**CHEMKA POOL STORM DAMAGE RECOVERY  
HASTINGS-ON-HUDSON**

**ADDENDUM NO. 2 – July 5, 2022**

drawing title:  
**ELECTRICAL**  
**BATHHOUSE DEMOLITION PLAN, POWER AND LIGHTING PLANS**

**E-1 of 5**

**4 UPPER LEVEL-PART PLAN**  
E-1  
3/8" = 1'-0"

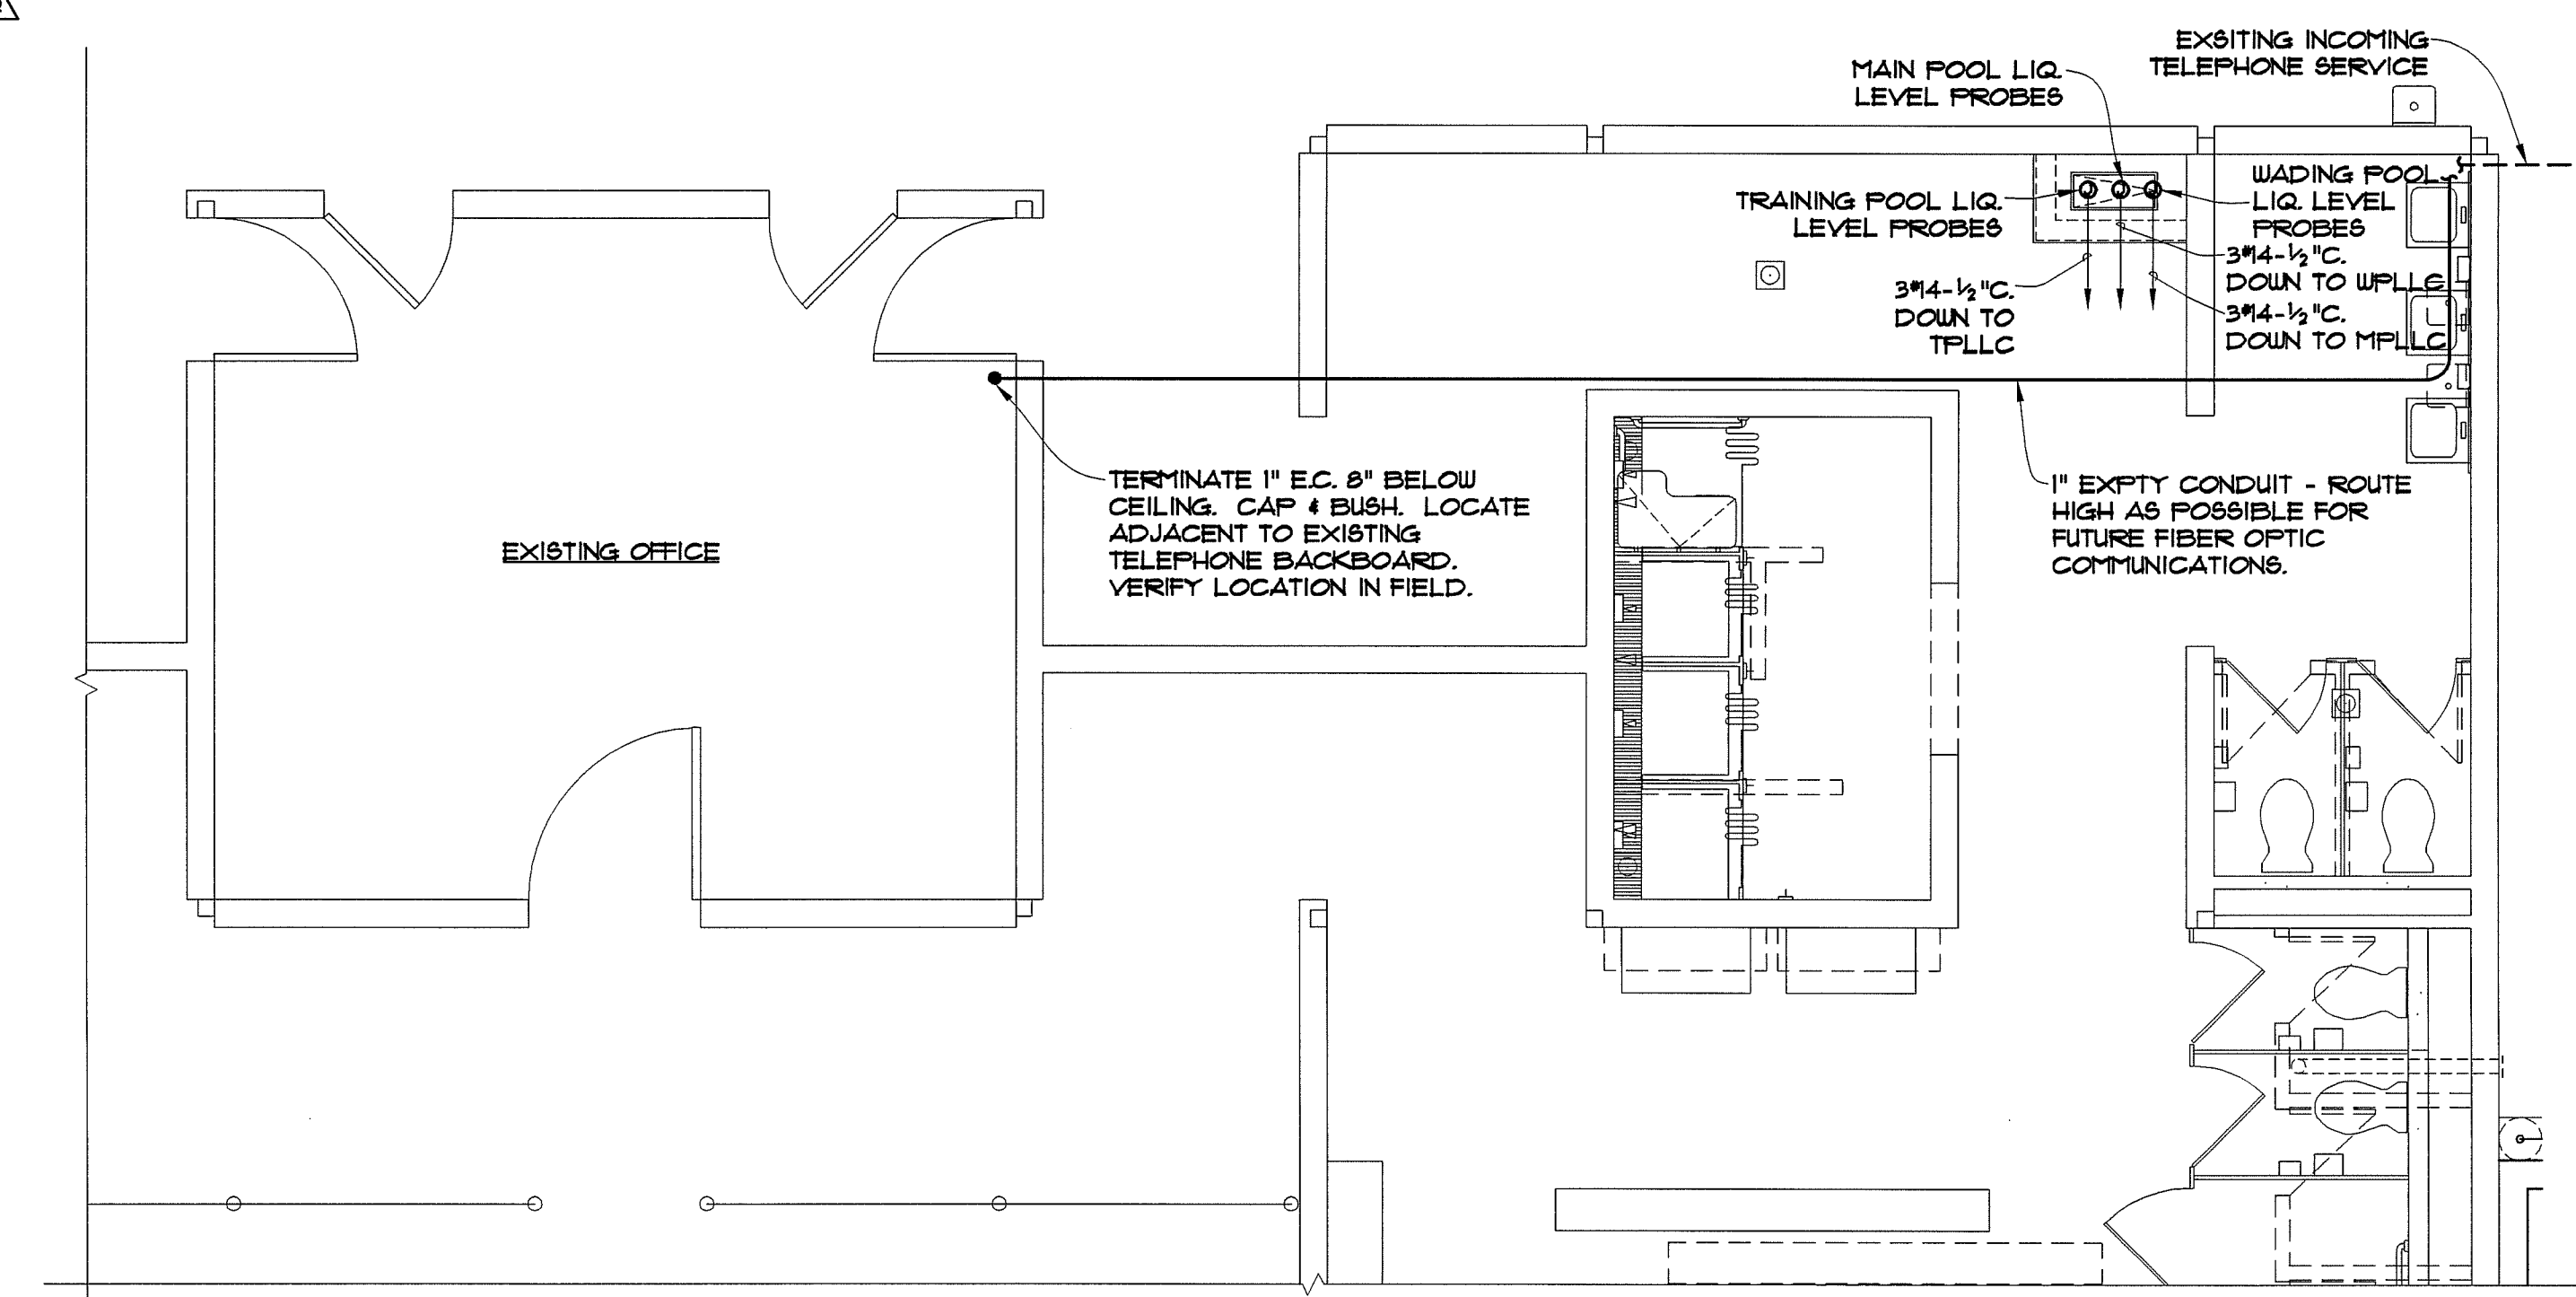
- A. On record Reference Drawing ES-1 of 2, Electrical Site Plan, Power and Lighting, an 11”x 18” x 12” DP pullbox is shown on the SITE PLAN-POWER AND LIGHTING plan on the deck on the north side of the Bathhouse. This pullbox is also shown on Contract Drawing E-02.

- B. Subsequent site surveys have not located this pullbox and it is assumed that the circuits serving the outdoor lighting and receptacles are run directly from the Filter Room panels to the exterior lighting and receptacles via an existing pullbox in the Filter Room.

- C. Add Reference Drawing E-1 of 5, Electrical-BATHHOUSE DEMOLITION PLAN, POWER AND LIGHTING PLANS to the drawing set.
- D. The contractor shall trace the existing circuits in the existing conduits which exit the Filter Room on the north wall and identify them as follows:

- 1. Circuit OLP-1, Light Tower P2
  - 2. Circuit OLP-2, Light Tower P1
  - 3. Circuit OLP-3, Light Tower P1
  - 4. Circuit LP-10, Convenience Receptacles (All Pools)

- 5. Circuit LP-12, Vacuum Cleaning Receptacle (Wading Pool)
  - 6. Circuit LP-14, Vacuum Cleaning Receptacle (Training Pool)
  - 7. Circuit LP-15, Vacuum Cleaning Receptacle (Main Pool)

- 8. Circuit LP-16, Vacuum Cleaning Receptacle (Training Pool)
  - 9. Circuit LP-17, Outdoor Emergency Lighting

These circuits shall be extended to new Panels OLP and LP as shown on new Contract Drawings E-02 and E-03 and as described in Ea below.
